**To:** The Design Advisory Board  
**From:** Mary O'Neil, AICP, Associate Planner *mo*  
**RE:** ZP 11-0864CA; 1 Golden Place  
**Date:** June 28, 2011

**File:** 11-0864CA  
**Location:** 1 Golden Place  
**Zone:** RM **Ward:** 5  
**Date application accepted:** May 4, 2011  
**Applicant/ Owner:** Katie Cate  
**Request:** 2 story addition with full basement.

E  
FRONT ELEVATION

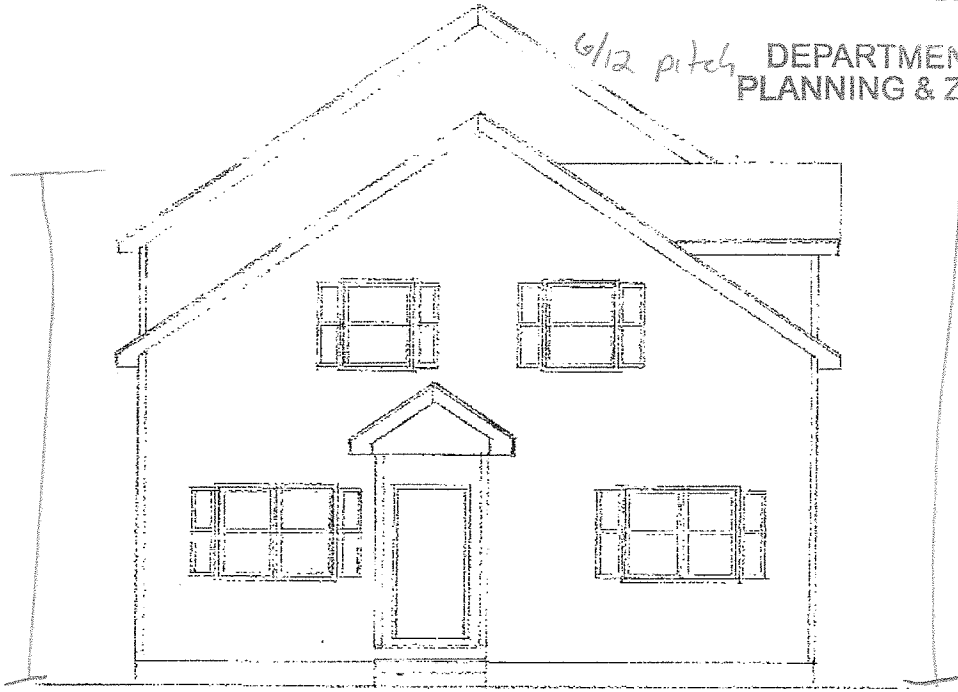
*The proposed addition rises seven feet in height from the existing dwelling, as scaled from the submitted elevations. This is a substantial difference from the existing height, and is therefore in conflict with this provision of the ordinance.*

The proposed two story addition behind a story-and-a half residence presents an abrupt massing and height conflict; specifically contrary to this provision of the ordinance. The addition clearly exceeds the height of the dwelling, and does not acknowledge and attempt to align with the existing building massing and height. Staff has encouraged a modification of the design; in either a cross-gable plan or lowered roofline, but the applicant claims difficulties in redesign.

The proposed gable roof is consistent with the existing building and other neighboring buildings; however the height is so extreme so as to be dissimilar and abrupt from the existing plan.

**Recommendation:** Table for redesign to lower the height of the rear roofline. An alternative method to “connect” the building components is suggested, i.e., a cross gable or new roof design with modified roof pitch to make the roof perceivably subordinate.

REAR  
W

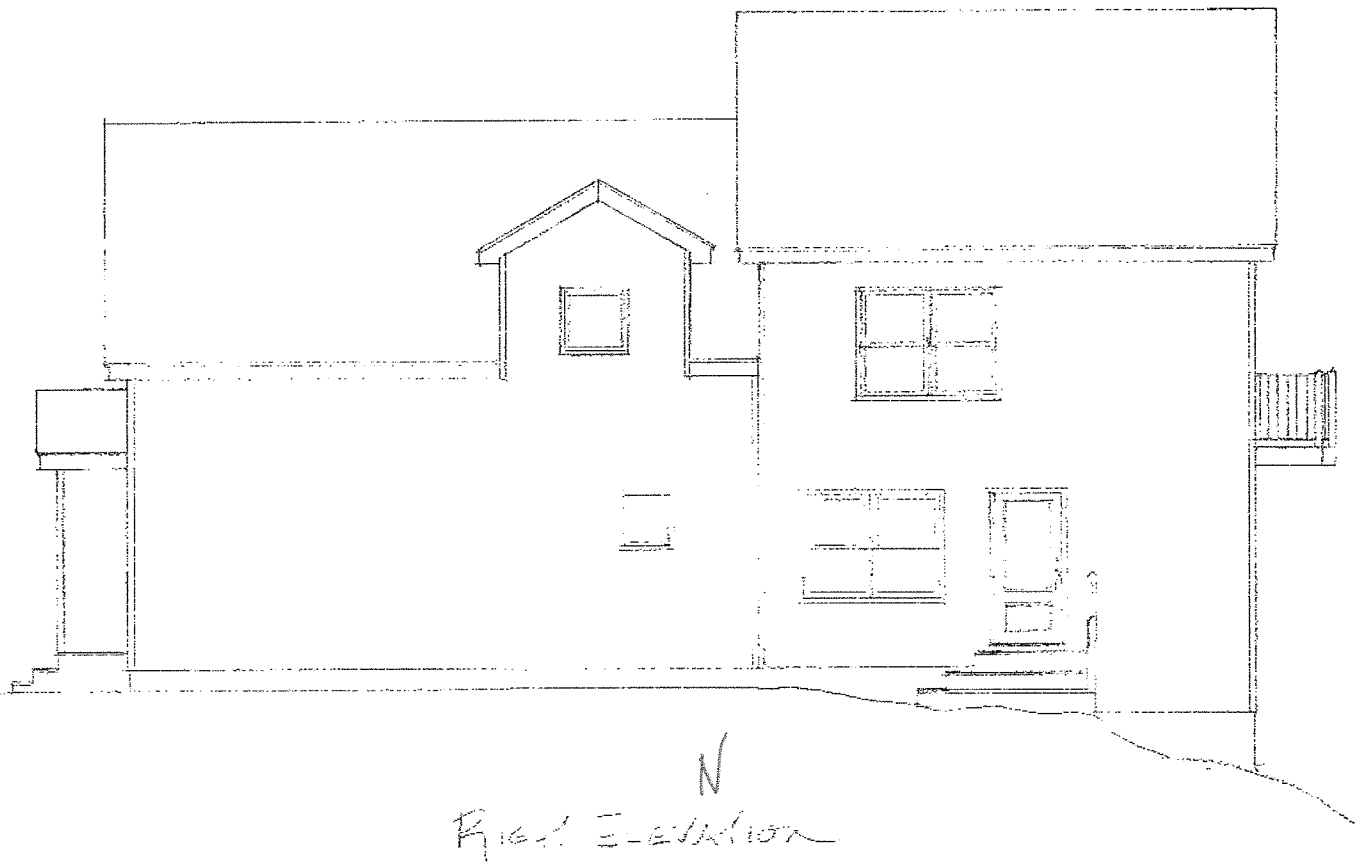
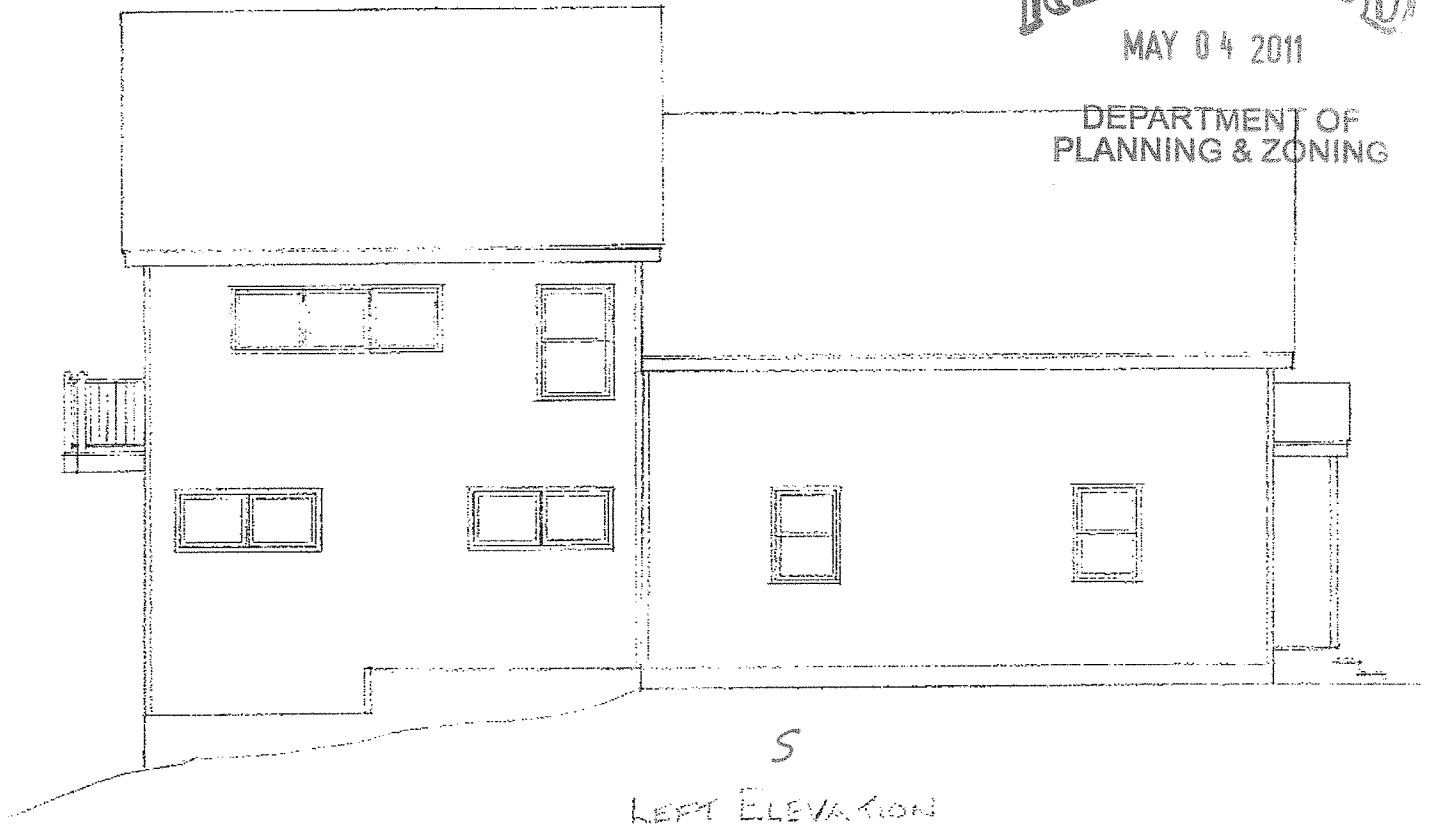
There is an existing canopy above the front door; however a proposed new entrance on a rear elevation has no roof cover to provide shelter from inclement weather.

A new doorway is proposed for a side elevation, and a walk-out access door at the rear. The double door noted in the secondary level may require a code-specific railing height to meet approval of the building inspector.

While no modifications are proposed for the primary elevation, the height of the looming addition and the long side elevations which may not provide a visual “break” between structural segments are not ideal proposals of a building addition. Off-setting a new building addition from the original structure, creating recesses, porches, or other visual interruptions create greater interest and building complexity. Elevations note a vertical differentiation between the existing dwelling and the new addition – this is preferred, rather than running clapboard or vinyl siding continuously across the entire 45’ expanse.
